14 October 2020

SSD 6965 - Barangaroo Building R4B (Mod 2) | Response to Submissions

Figure 1 Construction traffic arrangements – without Barton Street

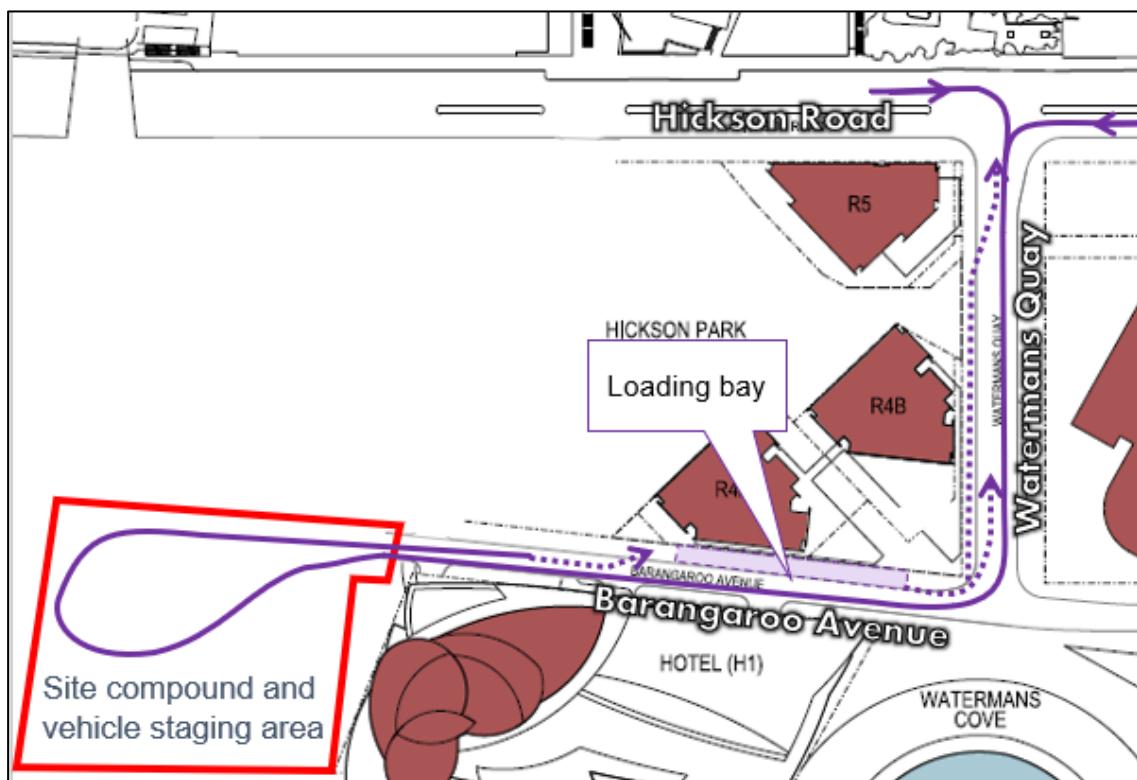
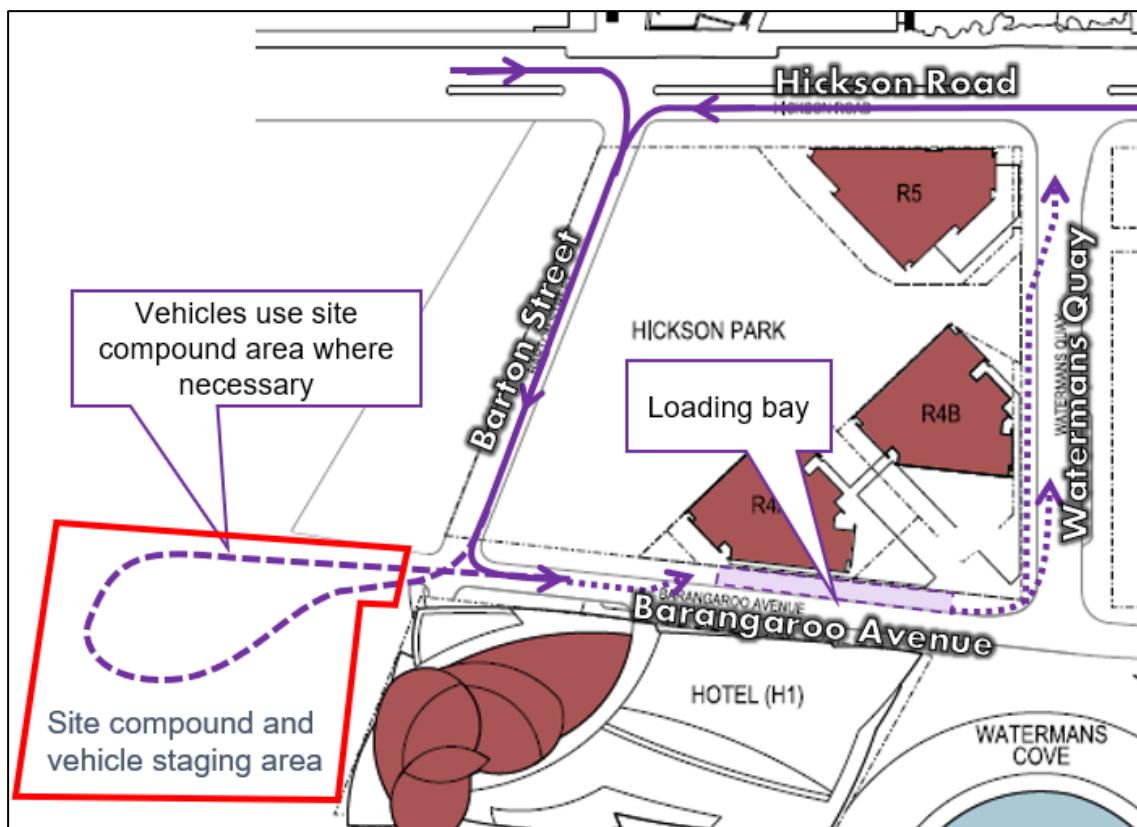
Several construction projects, including the Sydney Metro City and Southwest, are likely to occur at the same time as this development. The cumulative increase in construction vehicle movements from these projects could have the potential to impact on general traffic and bus operations within the CBD, as well as the safety of pedestrians and cyclists particularly during commuter peak periods.

It is requested that the Construction Pedestrian and Traffic Management Plan - Sub Plan (CPTMP) required under Condition C7 of SSD 6965 be updated in consultation with the Sydney Coordination Office within TfNSW to reflect the modification proposal. The applicant shall submit a copy of the final plan to the Coordinator General, Transport Coordination for endorsement prior to the issue of the construction certificate associated with the works under the subject modification proposal.

The key change with respect to construction traffic management is in relation to vehicle access and circulation around the construction site. This is a result of the introduction of Barton Street as a temporary construction road (with intention to also allow this as a general access road). This has been the subject of a Part 5 Review of Environmental Factors (REF), which was determined by Infrastructure NSW in June 2020. Construction of Barton Street has commenced and is expected to be open by the end of 2020.

A loading bay / works zone will be in place on the eastern side of Barangaroo Avenue so that construction vehicles for Building R4B do not impact general traffic movements. The loading bay will be contained within the construction site, with vehicles accessing the bay by travelling southbound on Barangaroo Avenue.

Barton Street would provide an opportunity for construction vehicles to bypass Watermans Quay and not have to turn around within the vehicle staging area – thereby avoiding any interface with the public access pathway and offering safety benefits for pedestrians. This arrangement allows for vehicles to continuously travel in one (anti-clockwise) direction without the need for turning around, reducing the distance trucks have to travel within the internal Barangaroo South road network. The arrangements for construction vehicles with and without Barton Street in place is shown in Figure 1 and Figure 2.

It can be concluded that, with the introduction of Barton Street and no additional traffic movements, arrangements for construction vehicles servicing Building R4B have improved when compared with the approved CPTMP for the site.

Therefore, in this context no update to the approved Construction Pedestrian and Traffic Management Plan - Sub Plan (CPTMP) required under Condition C7 of SSD 6965 is considered necessary to support the proposed modification to SSD 6965.
